BID: CPST-13
Tax Payer Service Center

ADDENDUM 1
DATED: February 11, 2021

FENCE DETAILS

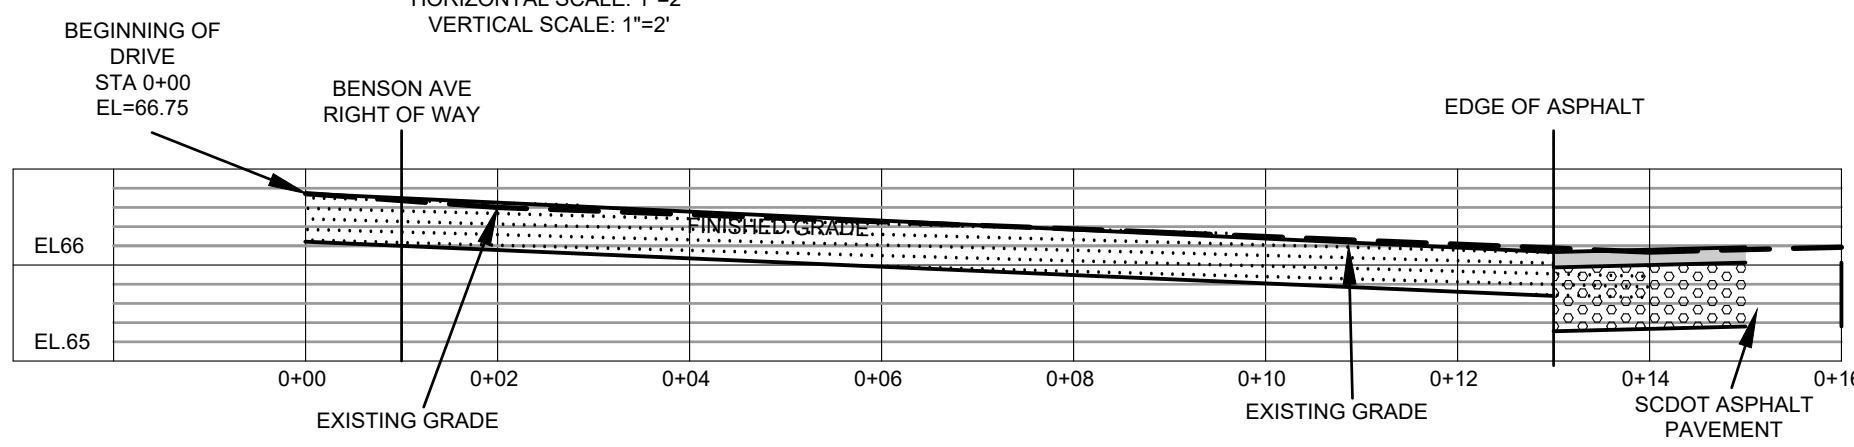
11. Question: A110 References Sheet A710 for fence details, however, the sheet ins not included in the bid documents. **Answer:** This missing A710 drawing has been included with this response.

12. Question: Need information on the aluminum fence and gate at the Mechanical yard behind the building?

45. Question: Key Note 32.30 Refers to a detail on Sheet A710, we do not have a Sheet A710 in our set of documents, can you please forward this sheet or clarify were the fence gate detail can be found.

Answer: Refer to drawing A710 which has been included with this response.

Answer: Refer to drawing A710 which has been included with this response.
46. Question: Mulch – The tree planting detail calls for 4" Pine Straw. The note on the bottom of the plant schedule calls for 3" hardwood mulch, dark brown. Please clarify.

NEW SITE PLAN

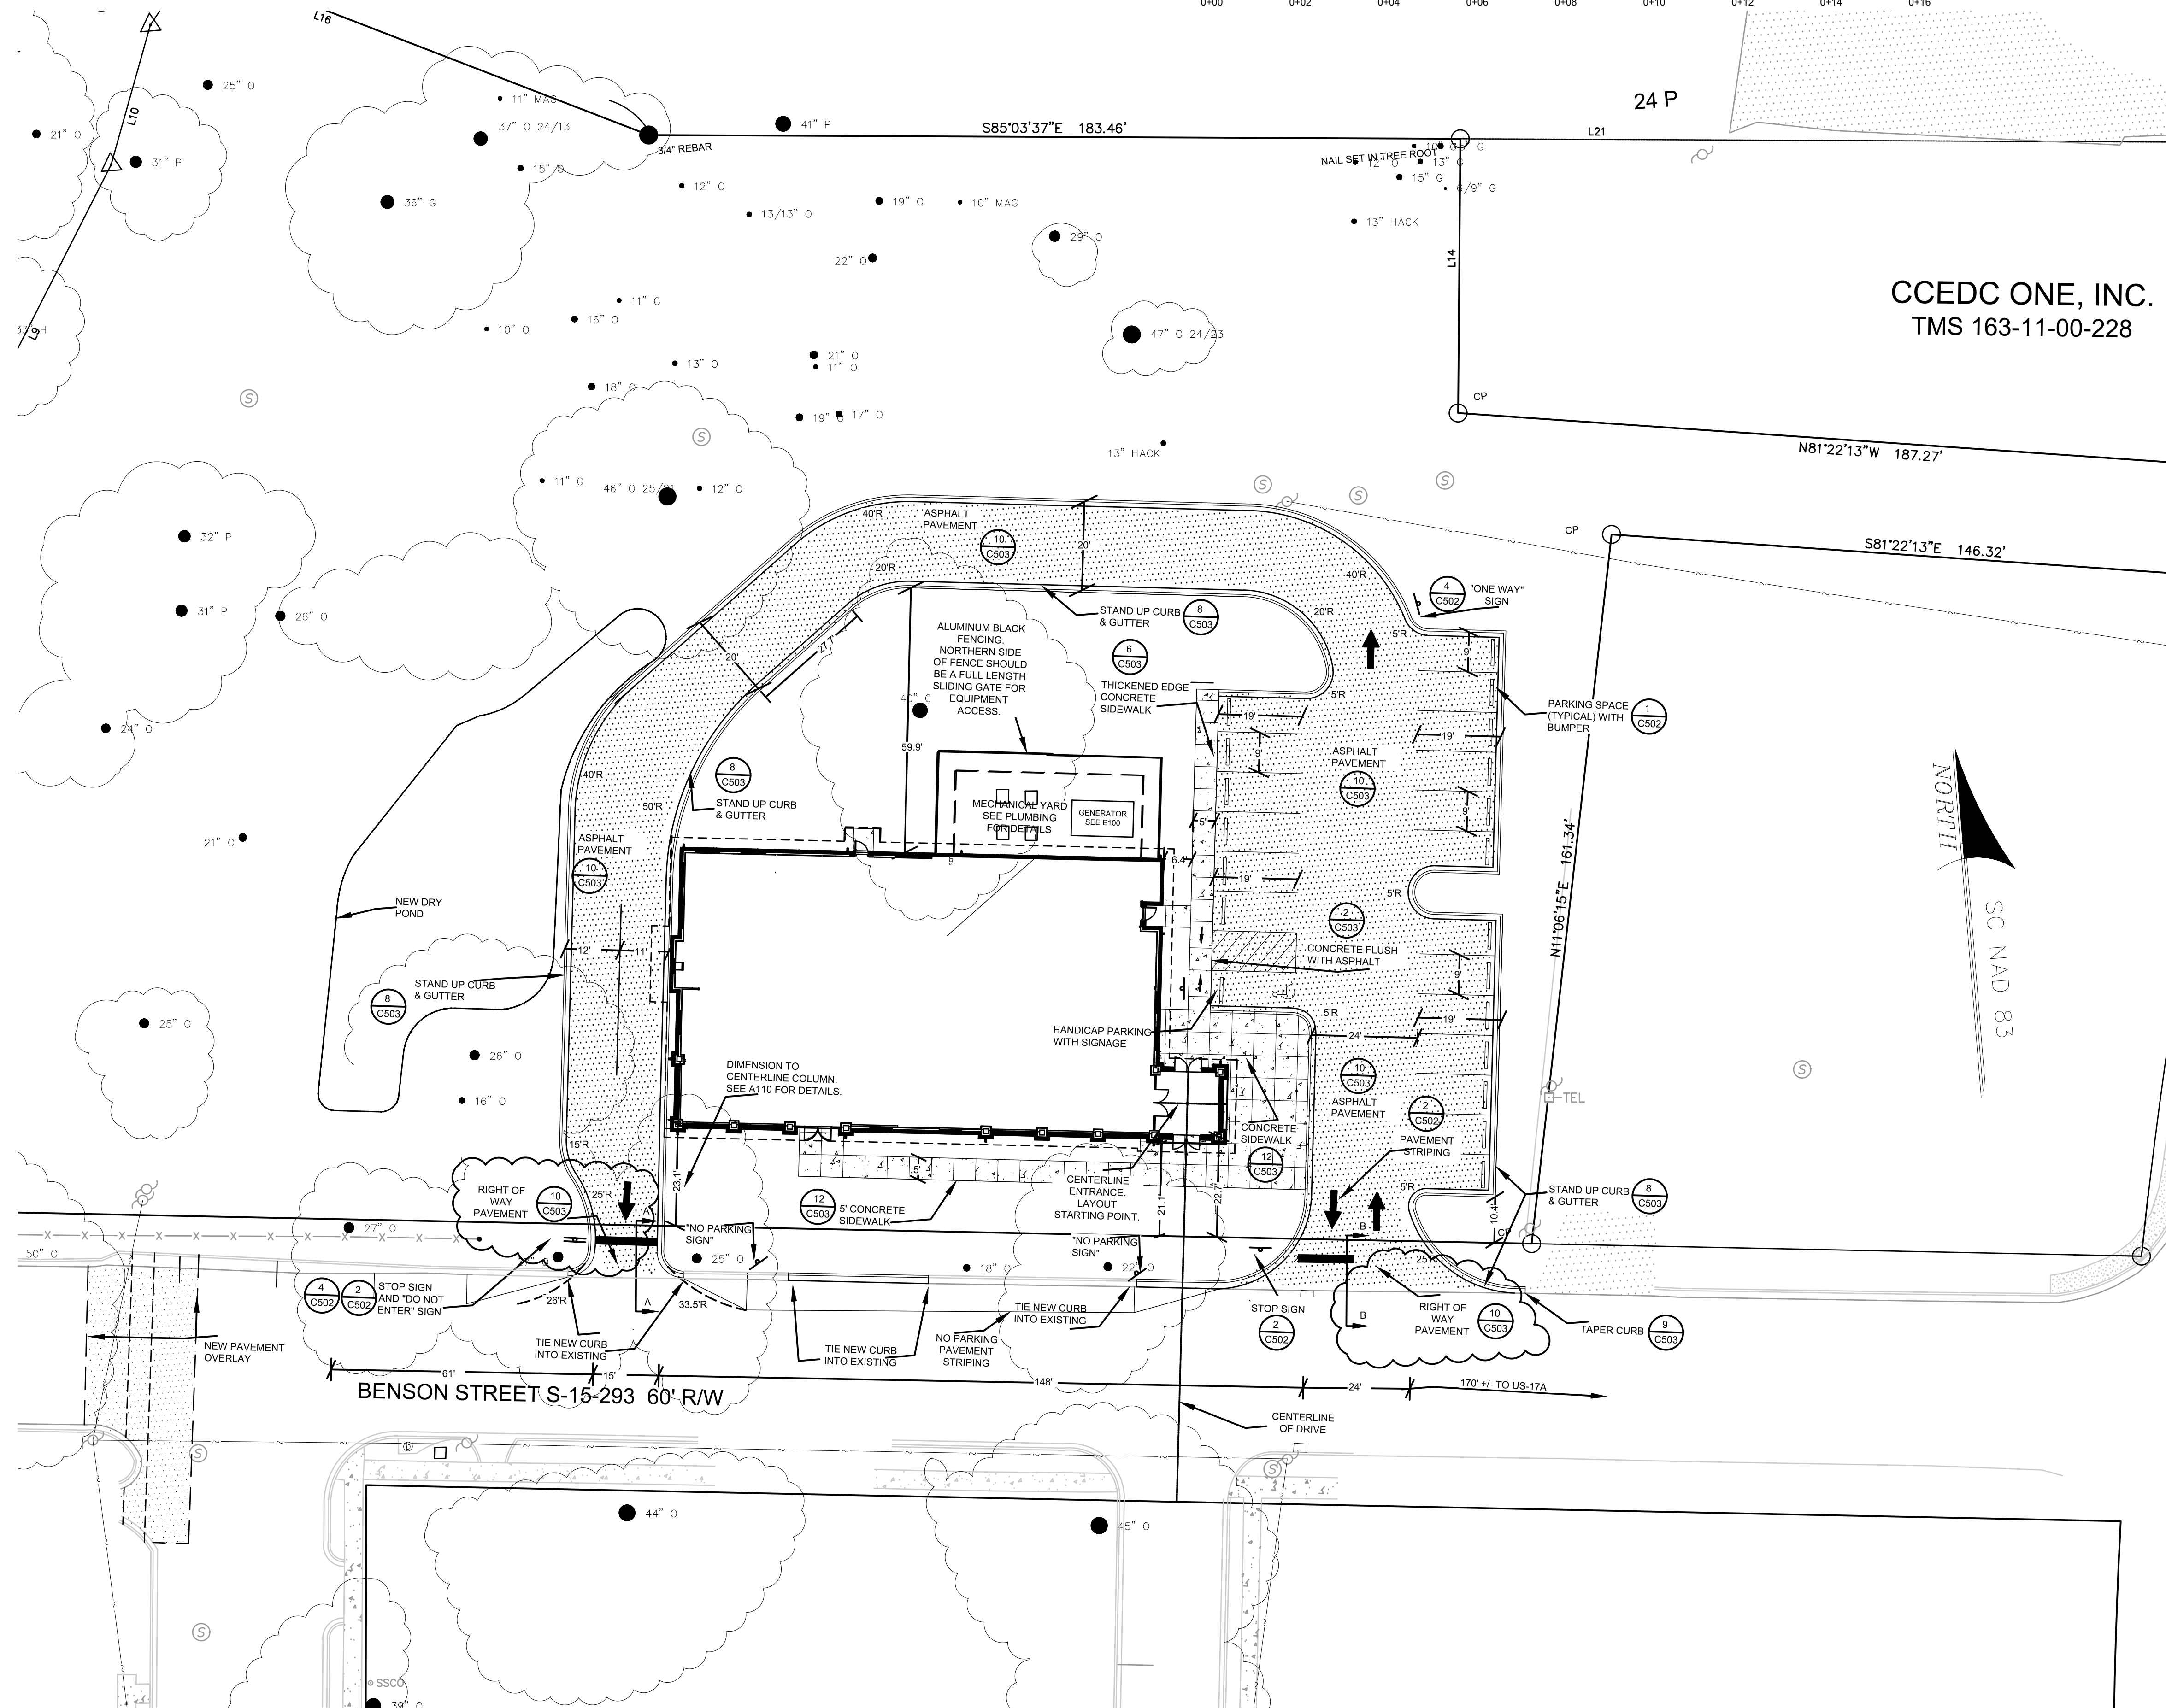
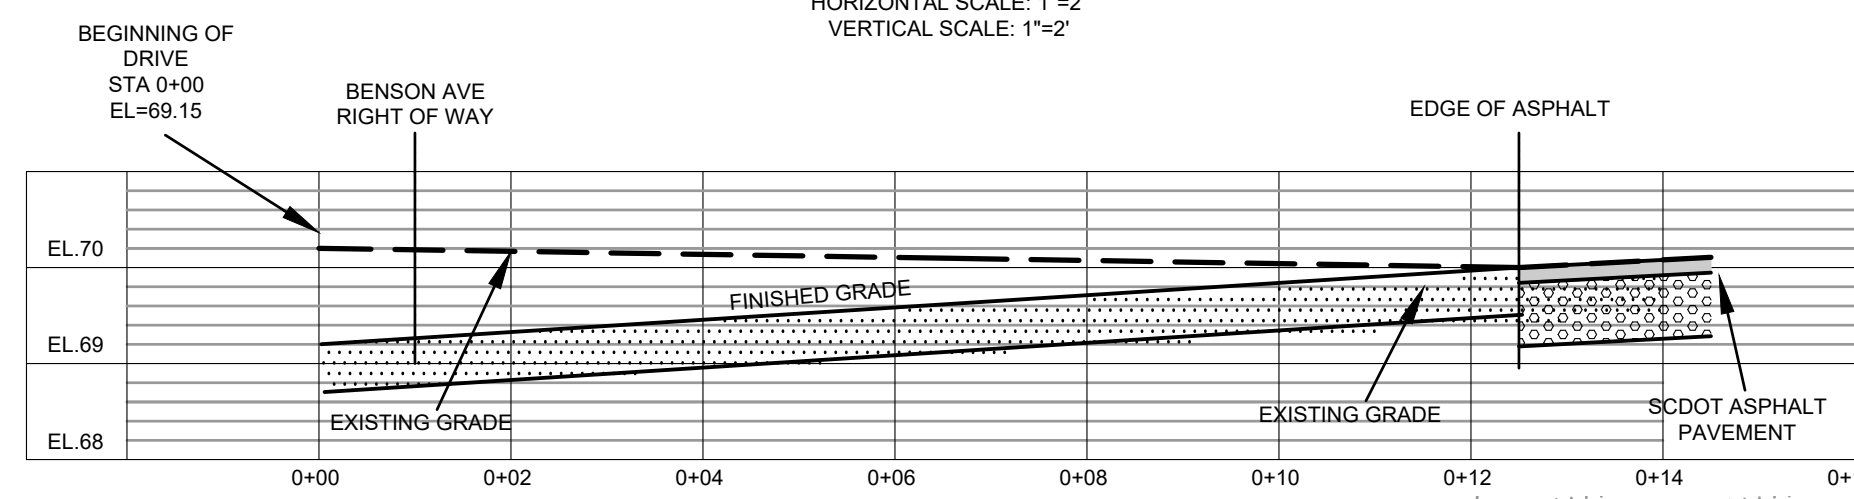
6. Question: Can you provide a detail for 13/C503 SCDOT RoW pavement?
Answer: The detail for the driveway should be referencing pavement detail 10 on sheet C503. A revised site plan referencing correct bubble to be provided.

C401

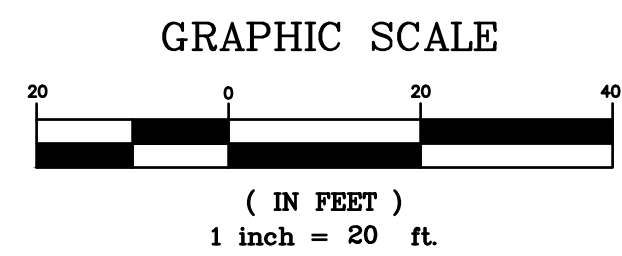
40. Question: The project utility page appears to be cut off. It does not show how the water line ties into existing and will need to know what size main line is. Will a new page be issued?

Answer: Revised C401 attached showing connection to main. Per note on utility plan the main is a 6 inch.
41. Question: There is not any specification for the floor/wall tile- it directs you to the plans which say tbd.
